**AMENDMENTS TO THE DRAWINGS:**

## **REMARKS**

# ANNOTATED SHEET SHOWING CHANGES

FIG. 1

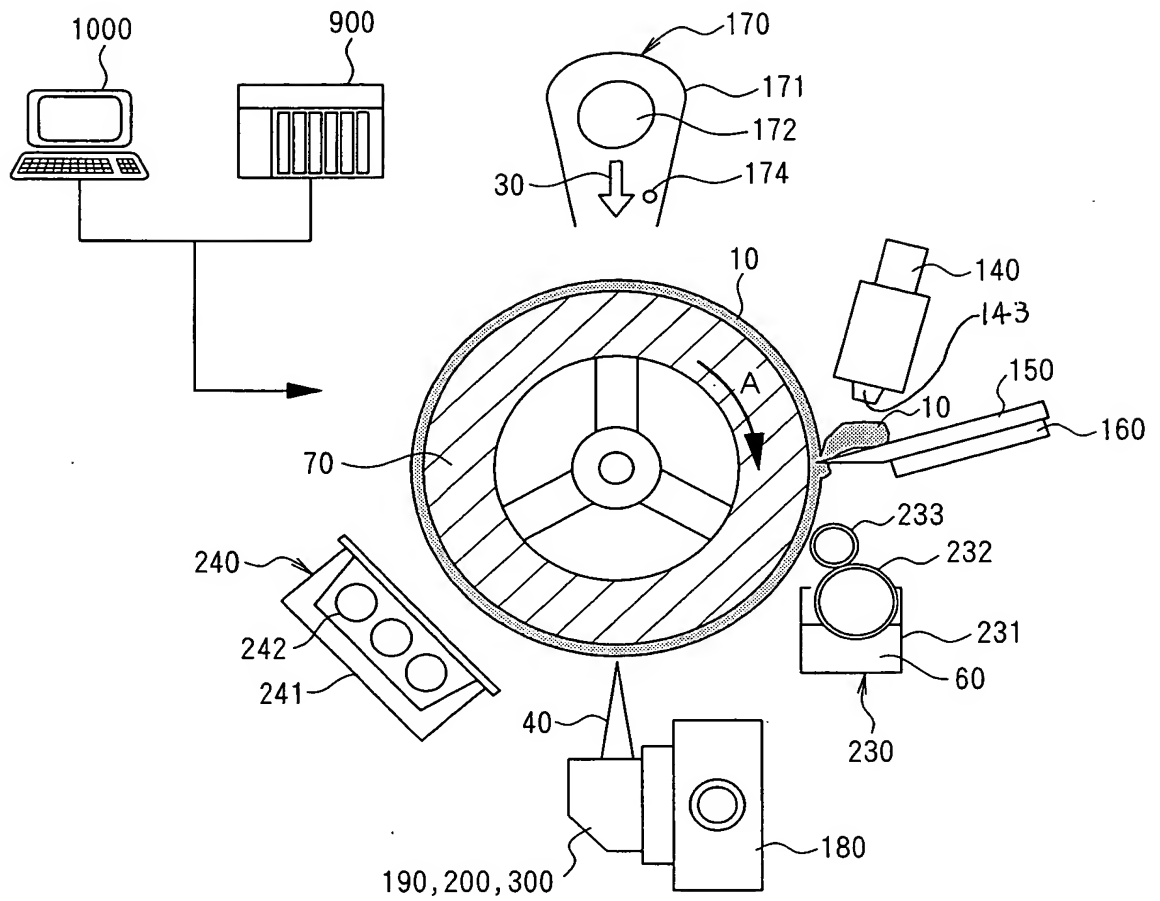
Also, enclosed are Annotated and Replacement Drawings of Figs. 1-3 that include the reference numerals added to page 32. These reference numerals are numerals 71 and 72 in Fig. 2 and numeral 143 in Figs. 1 and 3. No new matter is being added by these amendments and their entry is therefore requested.
